**Ignition unit of ROTAX engine 912 A**

Revision 1

**Airworthiness Directive
No. 75**

Subject: Ignition for Rotax 912 A Series, all engines up to S/N 4,076.022

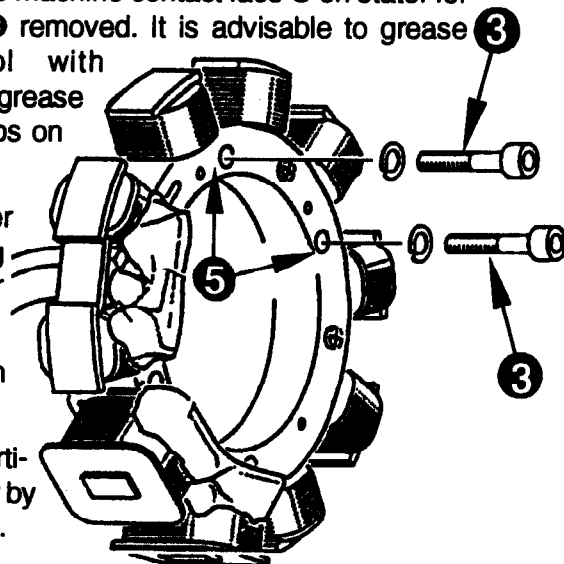
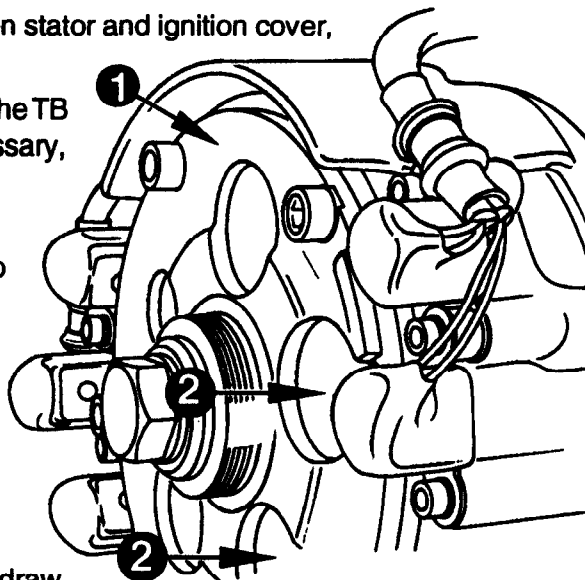
Disconnect battery. No need to withdraw magneto housing ❶ with magneto ring. Remove at least 2 of the 4 Allen screws ❸ and lock washers for stator attachment via the openings ❷ in the magneto housing.

■ **ATTENTION:** Make absolutely sure that no foreign matter (lock washer or screws) will stick to the magneto ring.

Use spot-facing cutter ❹ or similar tool to machine contact face ❺ on stator for the screws ❸ removed. It is advisable to grease cutting tool with Lithium-base grease to collect chips on cutter and not on magneto ring.

Refit screws M5 along with lock washer and tighten to 6 Nm. To ensure lasting ground connection, treat contact faces for screws with Lithium-base grease.
